Bull. 1335 Instruction Manual

Revision to Publication 1335-5.0

12 - 36 Amp Switching Modules

56 - 96 Amp Switching Modules

BULLETIN 1335 56 & 69 AMP DRIVES
POWER SWITCHING MODULE — P/N 120784

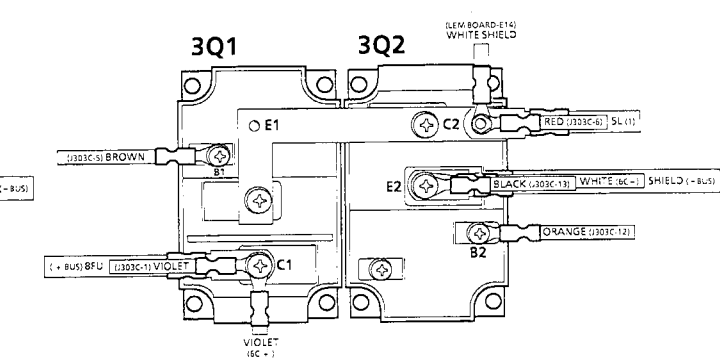
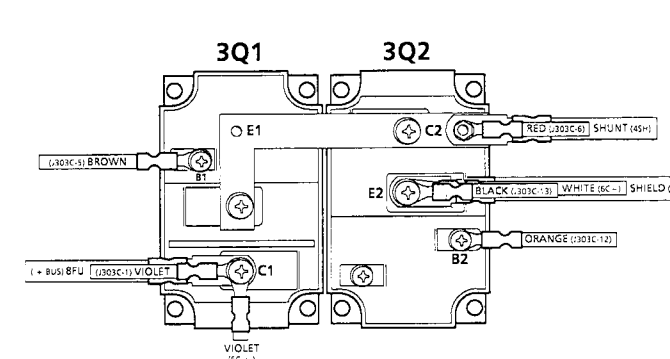
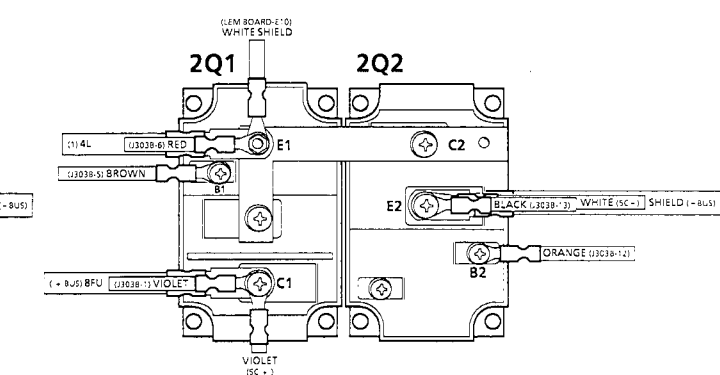
Power Switching Module 1Q1, 2Q1, 3Q1, 1Q2, 2Q2, and 3Q2
P/N 201411

CAUTION: Bulletin 1335 56 through 96 Amp Drives use two Power Switching Modules connected in series in each phase of the three-phase output. To avoid damage to the Drive, modules connected in the same phase must use the same part number. This will require changing both modules in a phase even though only one module needs to be replaced. Old and new modules may be identified by their physical difference. See page 3 for connection details.

P/N 120784

BULLETIN 1335 77 & 96 AMP DRIVES
POWER SWITCHING MODULE — P/N 120784

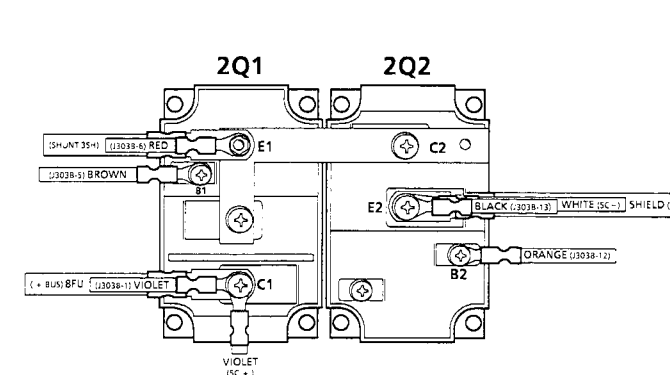
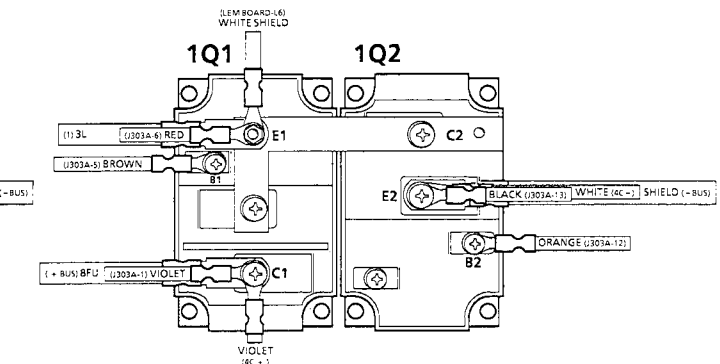
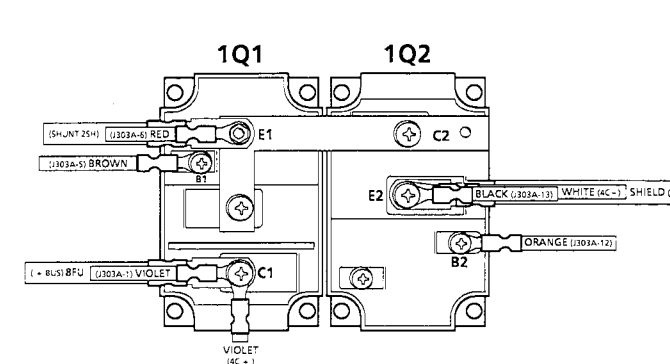
Power Switching Module 1Q1, 1Q2, 2Q1, 2Q2, 3Q1 and 3Q2
P/N 201411

CAUTION: To avoid damage to the Drive, **Power Switching Modules** connected in the same phase must use the same part number. This may require changing both modules in a phase even though only one module needs to be replaced.

P/N 120784
